## Keswick Creek Open Space Concept Plan

Bike Adelaide wishes to express support for the Keswick Creek Open Space Concept, creating a new walking and cycling link in West Torrens and valuable new public green space. In relation to the consultation of the concept plan, we submit the following feedback for consideration.

*Concept image showing node space along path with dark-coloured bollards narrowing path.*

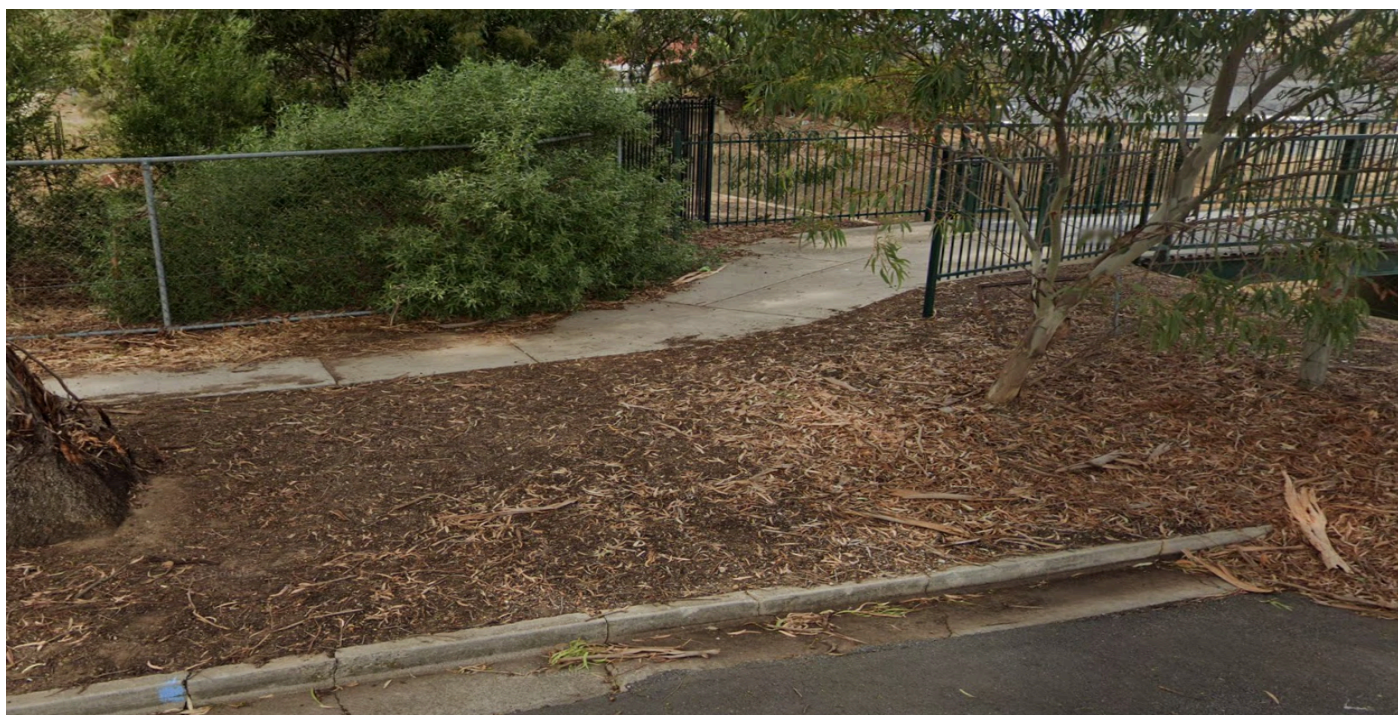
We note the concept images include bollards at some of the nodes (below). While concept images are indicative only, bollards in shared spaces are extremely contentious in active transport and are often found to create unnecessary hazards for path users. Austroads guidance for some time has been to not install bollards unless a demonstrated hazard exists, which should be recorded in a Traffic Impact Statement. The Austroads guidance stipulates design elements which reduce the risk posed by bollards themselves if used, none of which are indicated in the concept images.

Bollards create clipping hazards with handlebars, pedals and panniers. International evidence demonstrates bollard collisions cause cyclist injuries including death. Bollards in the centre of paths, or narrowing paths, along Little Para River trail in the City of Salisbury have been progressively removed to avoid further incidents in that area.

Narrowing of paths to a width that does not allow a cyclist to pass a pedestrian, a runner to pass someone with a pram etc inevitably leads to a conflict point in the path. We advise against the use of bollards along the path where they mostly serve as a hazard to path users. Additionally, frustration at their presence can result in some cyclists choosing to speed up to pass slower path users before the path narrows, creating the effect of a *less* calm and pleasant shared space. We strongly advise against the use of bollards given there is no clear hazard they intend to address and are counterproductive to safe and comfortable shared open space.
